NUMBER 17

GENERATOR MOUNTING BRACKET ALIGNMENT

1958-59 Lincoln
and Continental

Fig. 1 - Generator Mounting Bracket Installation Conditions

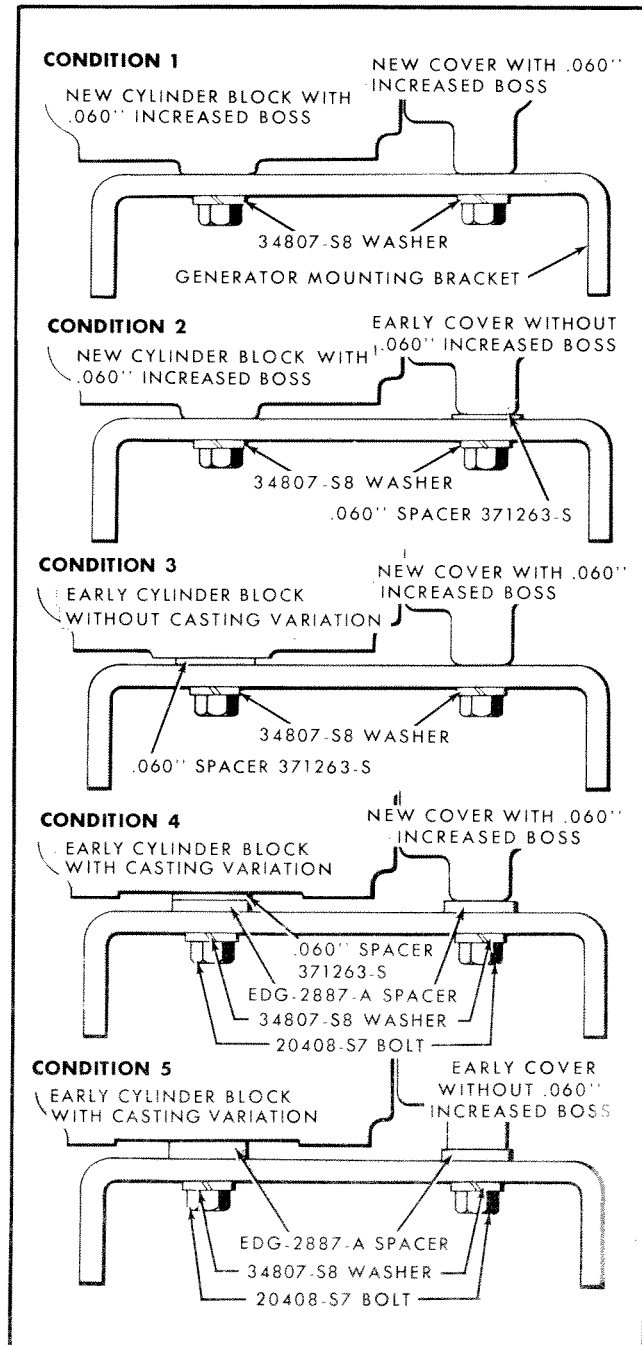
New cylinder blocks and cylinder block front covers are being used which have .060" increased height at the generator mounting bracket bosses. The increase in boss height has been added to eliminate any block casting variations or improper machine boring which could cause misalignment and subsequent generator bearing or belt failure.

The new parts can be used in any combination with the early type parts providing they are used in conjunction with the necessary spacers and washers as shown in figure 1.

If a mounting bracket is found misaligned, distorted or broken on an engine not having the increased boss height, install a new bracket with the spacers, washers and bolts as shown under condition number 4 or 5 in figure 1.

Part number UP-371263-S is classified "C".
